BID ADDENDUM #2

Nanuet Bond Projects Phase 2

Date: January 11, 2023

ISSUED: BID SET ISSUANCE
DATE: DECEMBER 15, 2022
SCALE: As indicated
SHEET NAME:
ENLARGED FLOOR
PLANS- ALTERNATES
SHEET NUMBER:
HS-A111

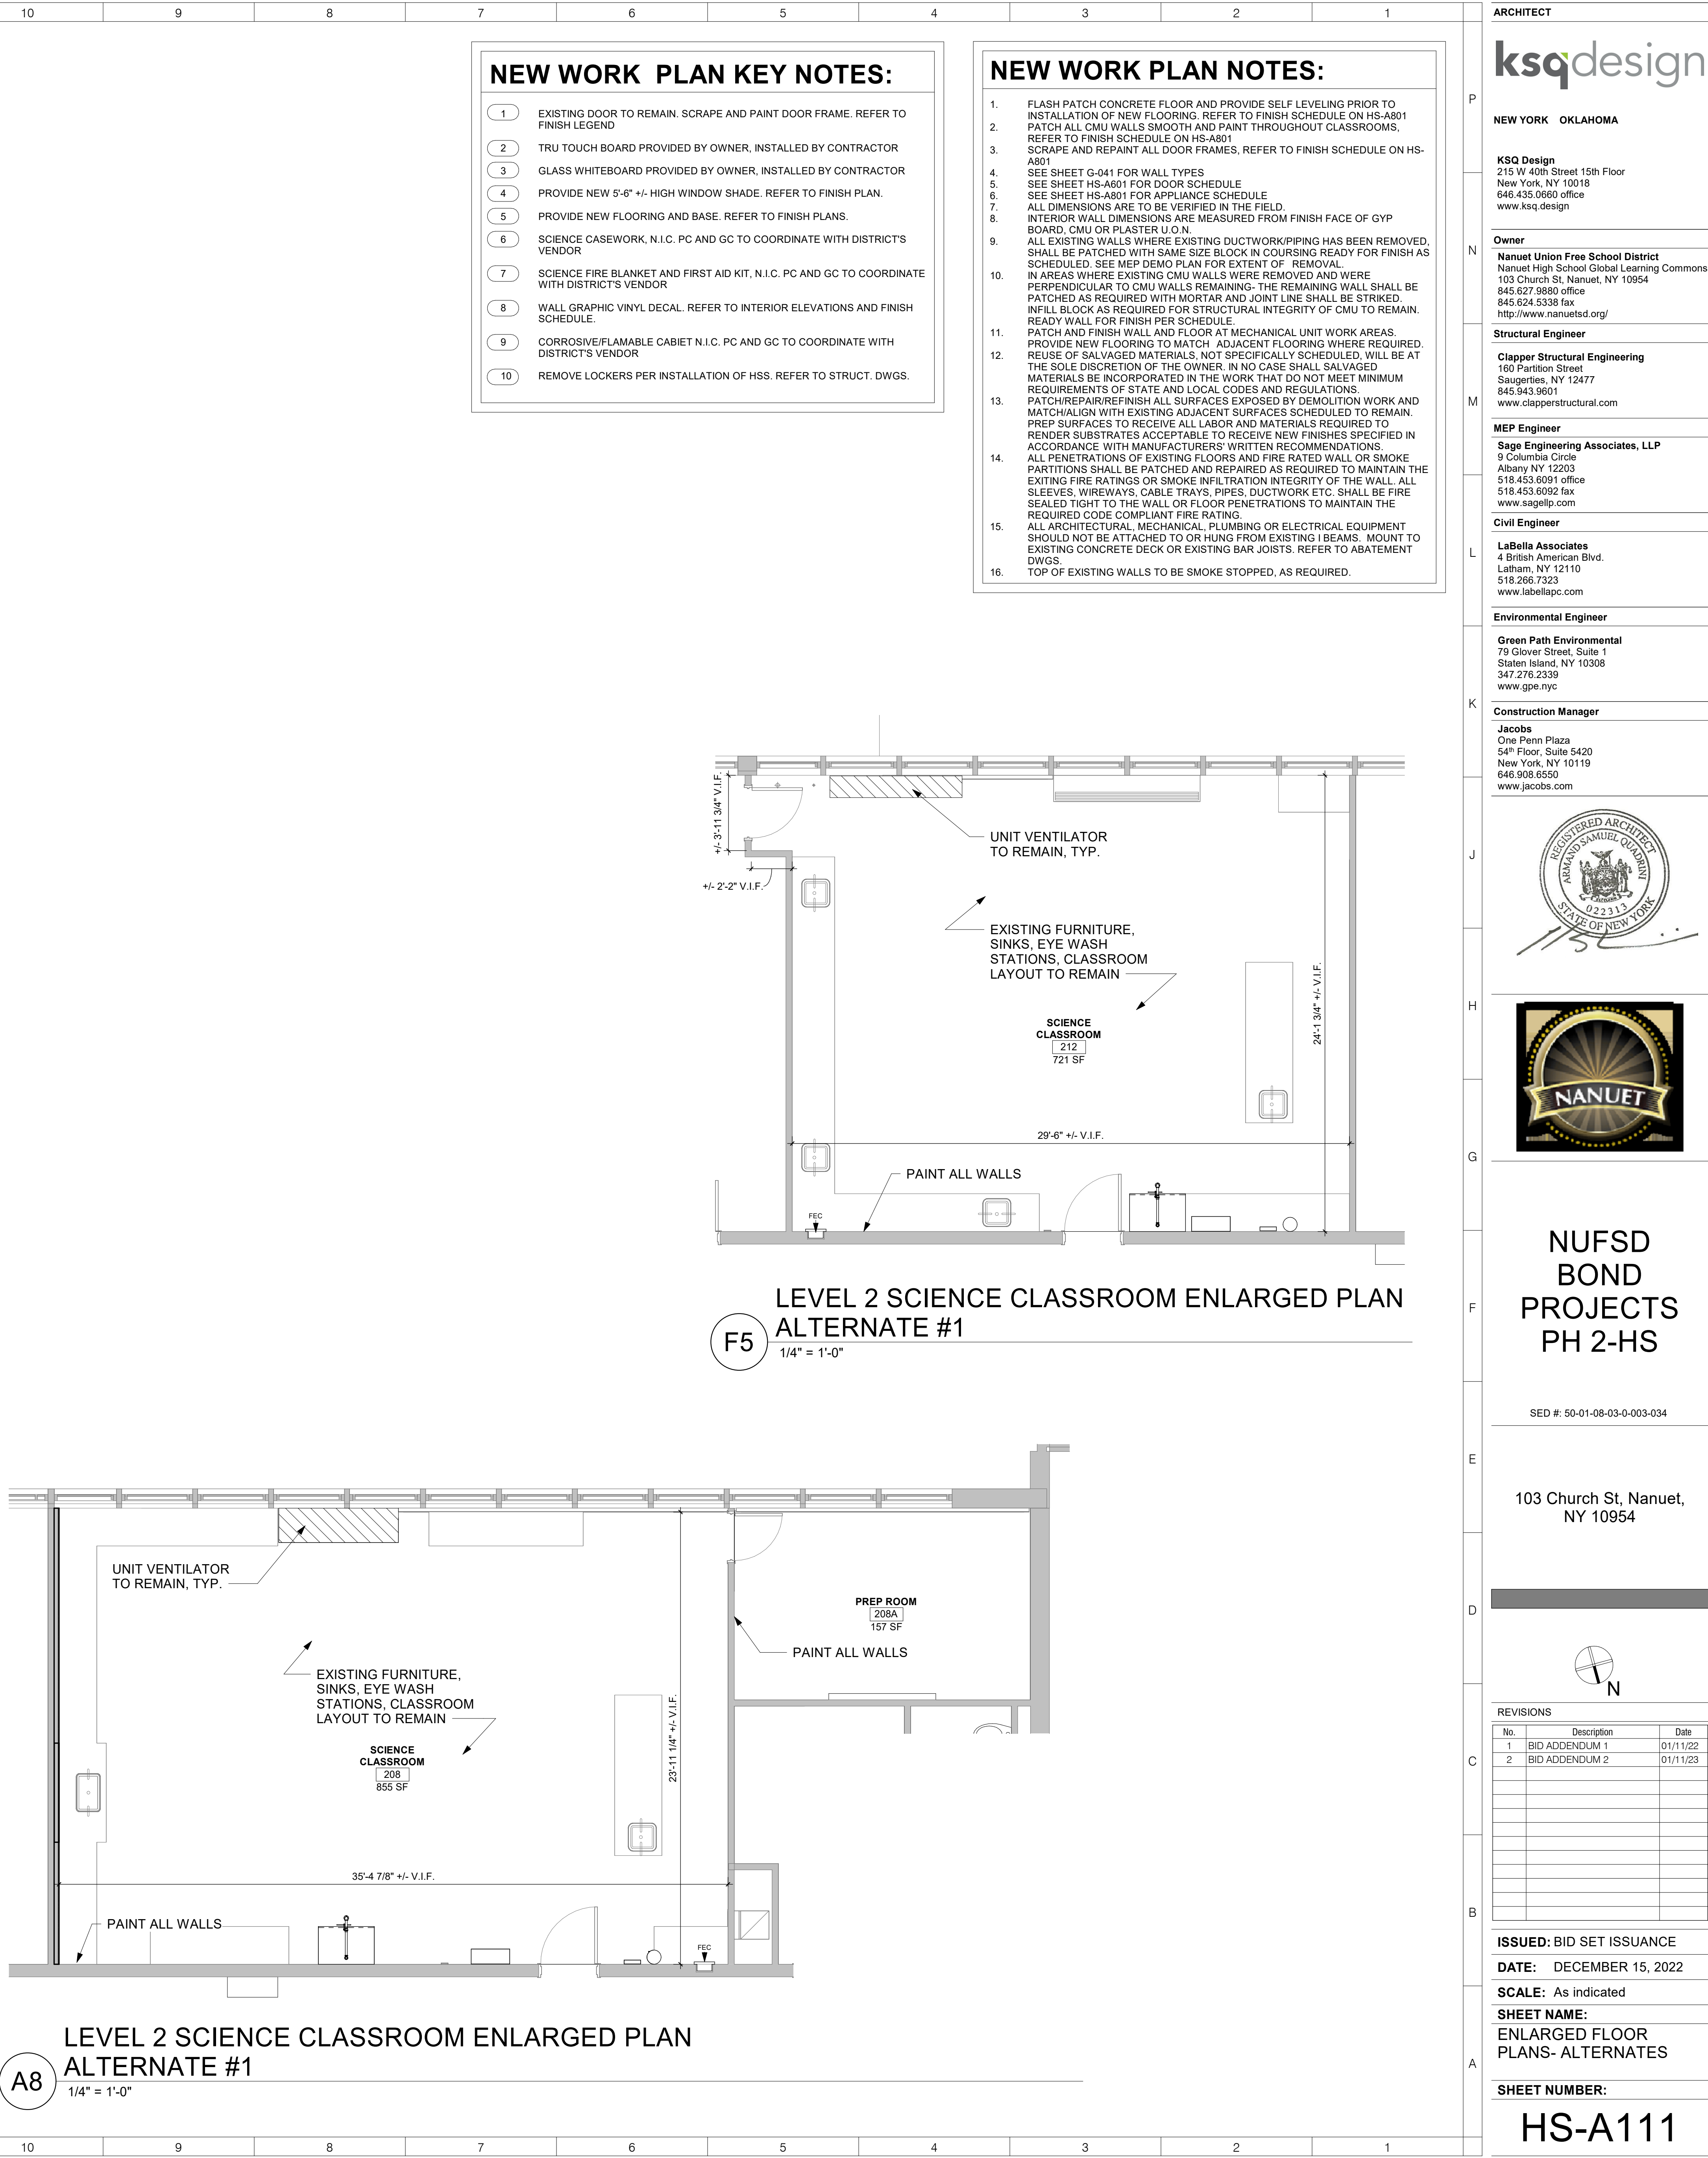
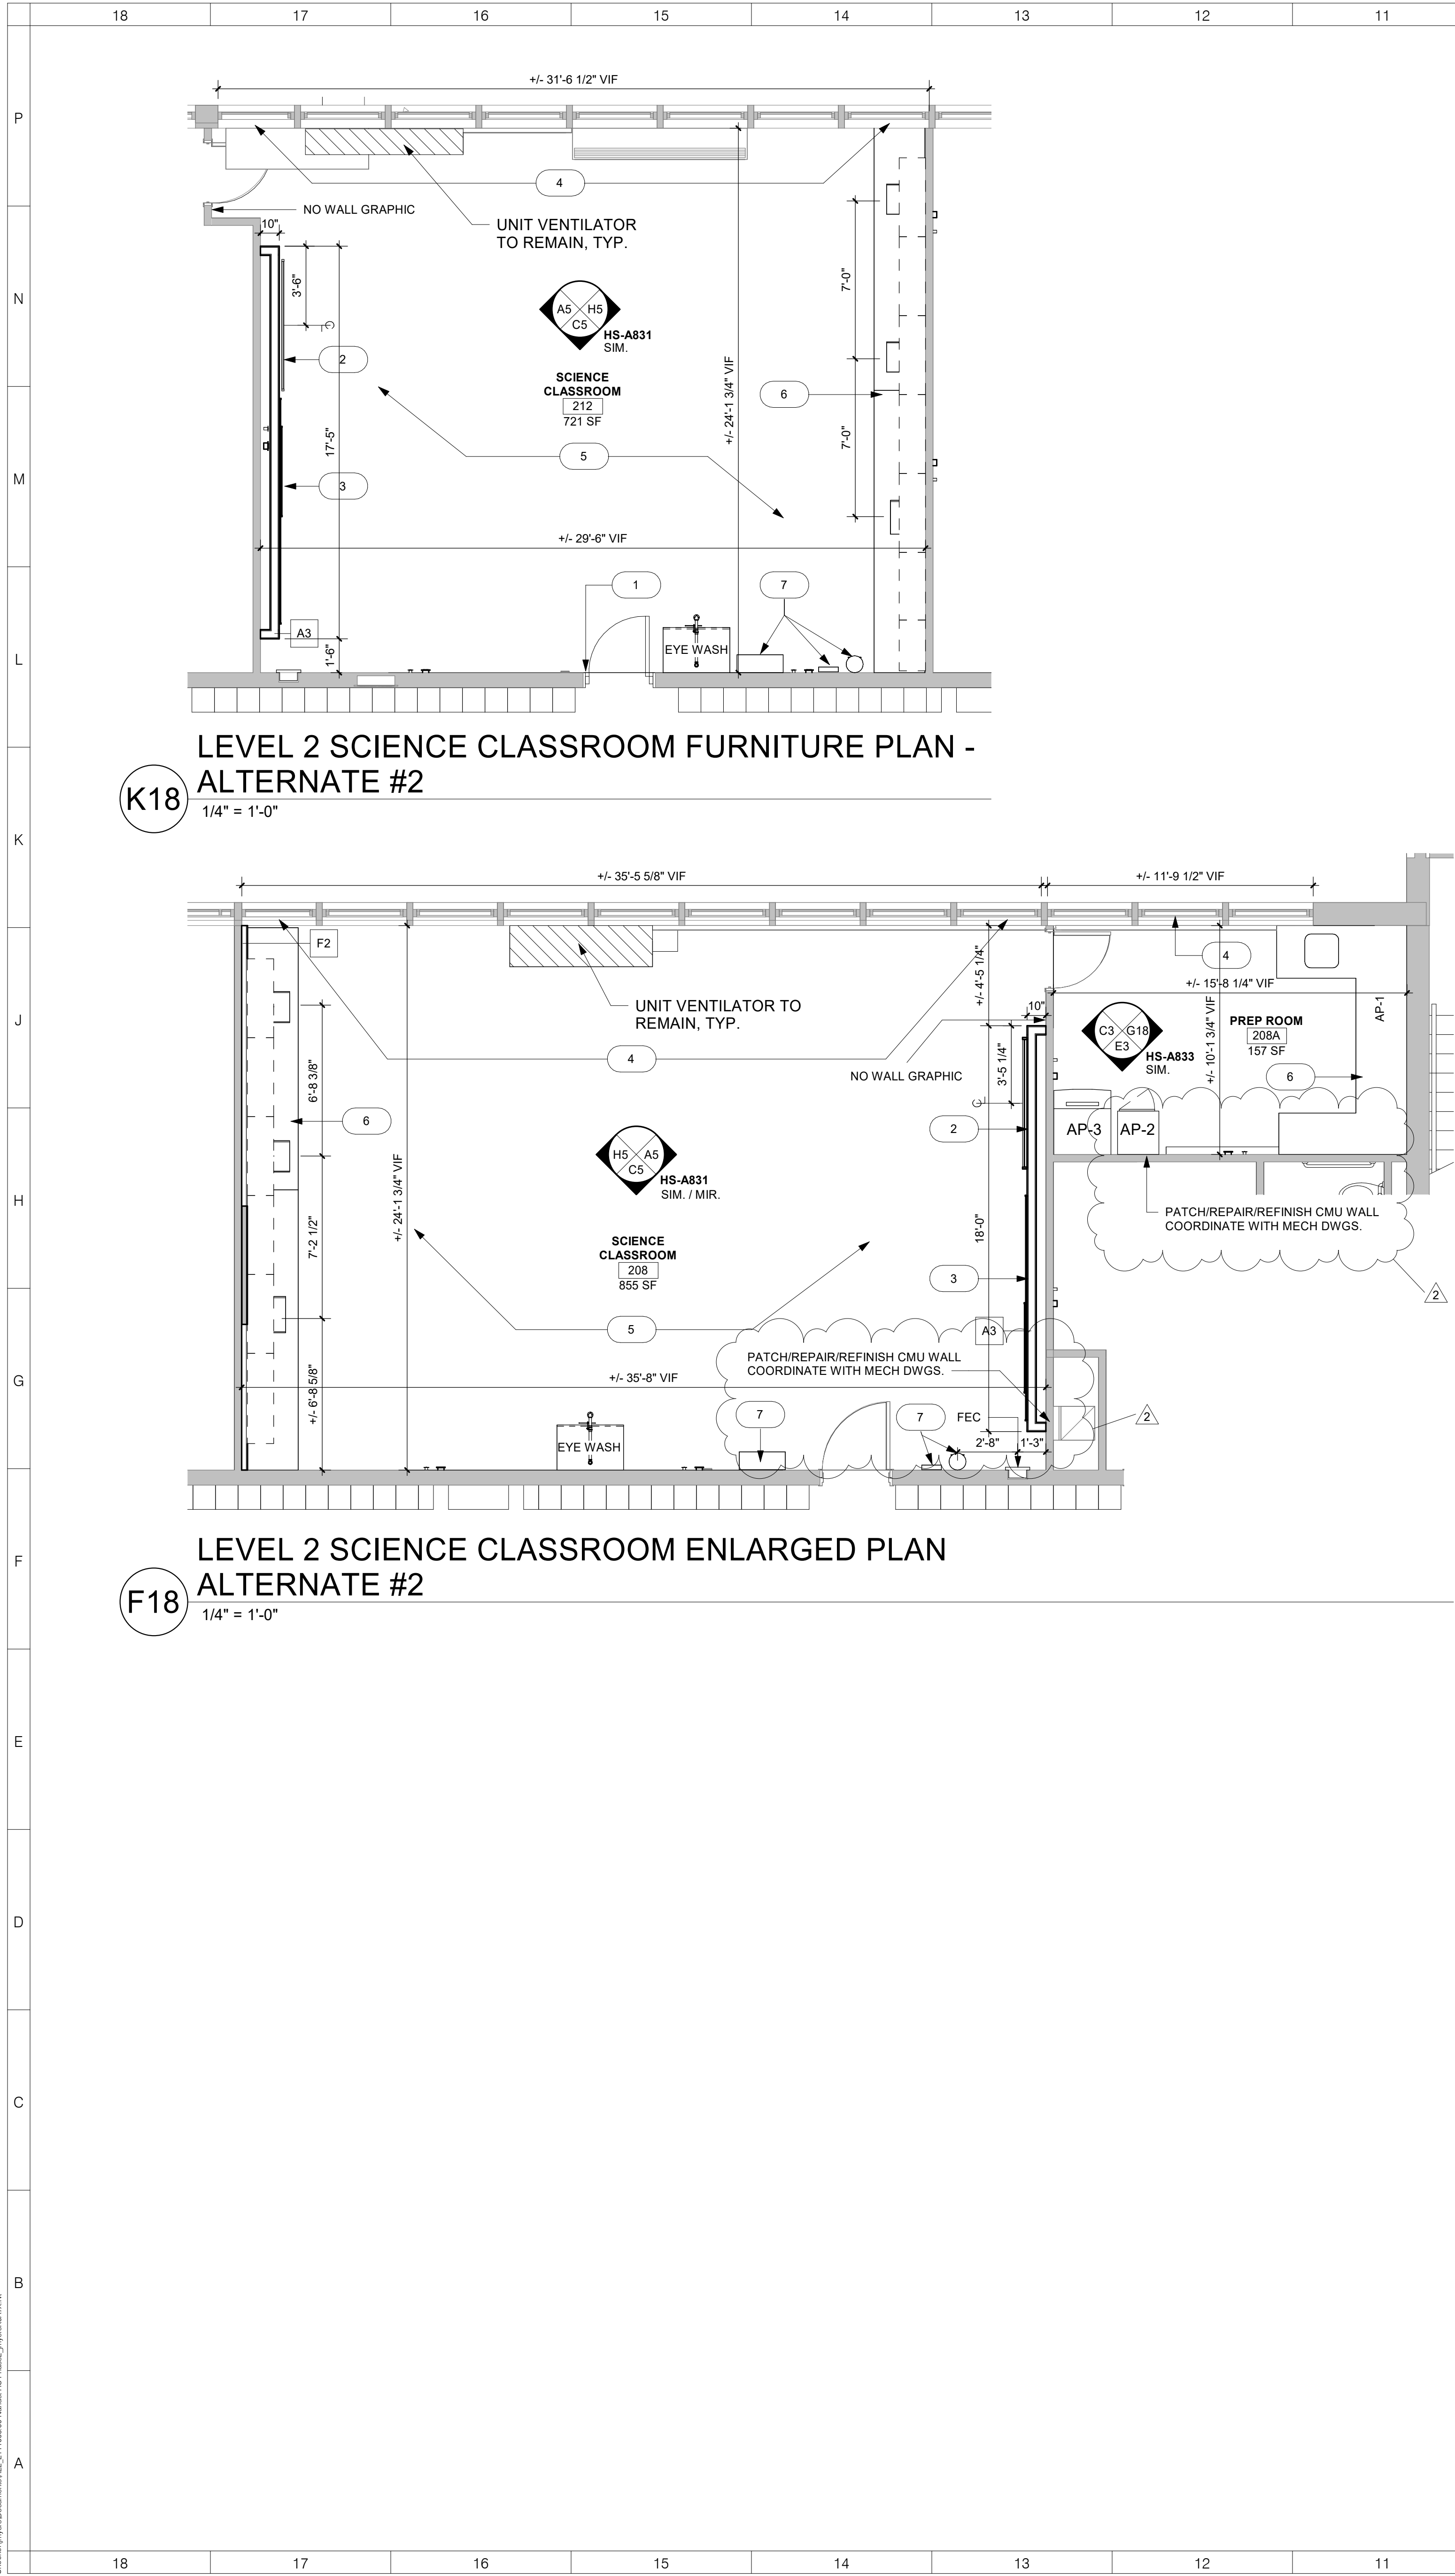
1. Drawing **BM-A801: INTERIOR FINISH PLANS & SCHEDULES**
 - A. Revisions to Finish Plans, Finish Legend, Room Finish Legend and Floor Finish Legend.
2. Drawing **HS-A111: ENLARGED FLOOR PLANS ALTERNATES**
 - A. Revisions to Alternate #2 enlarged floor plan.
